February 20, 1984

Re: Catawba Nuclear Station  
Docket Nos. 50-413 and 50-414

Duke Power Company  
Catawba Nuclear Station  
Unit 2 Steam Generator Modification

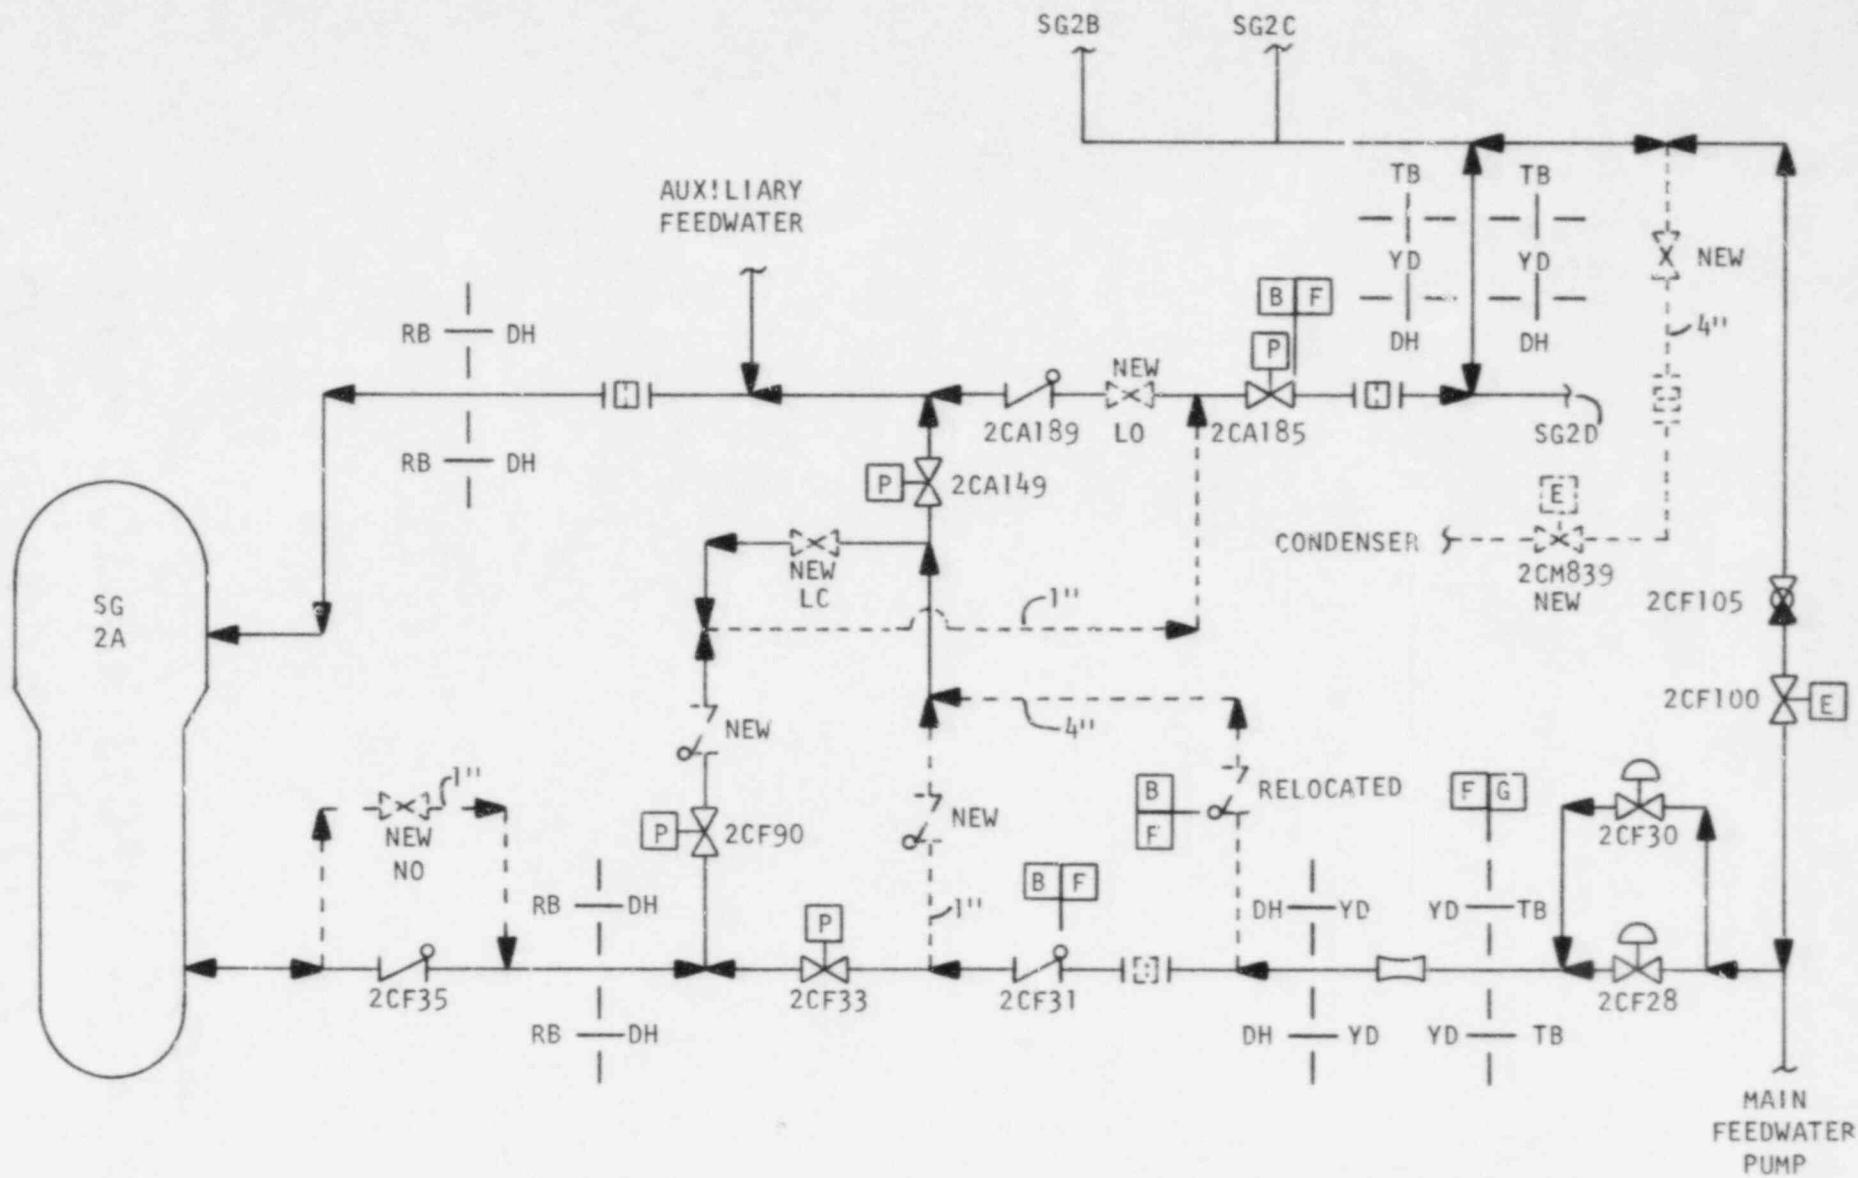
The piping changes for feedwater flow diversion consist of the addition of an orifice in the main feedwater pipe to increase flow resistance downstream of the new auxiliary feedwater bypass connection (see attached figures). A path for reverse flushing of the feedwater line was also added for compatibility with the Unit 1 changes as shown by the 1" dashed lines. Appropriate logic and alarms will be added to inform the operator of high flow through the main nozzle. Work is nearing completion for this part of the modification with tube expansion scheduled to begin in February, 1984. All work on the modification of the Catawba Unit 2 steam generators will be completed prior to fuel loading.
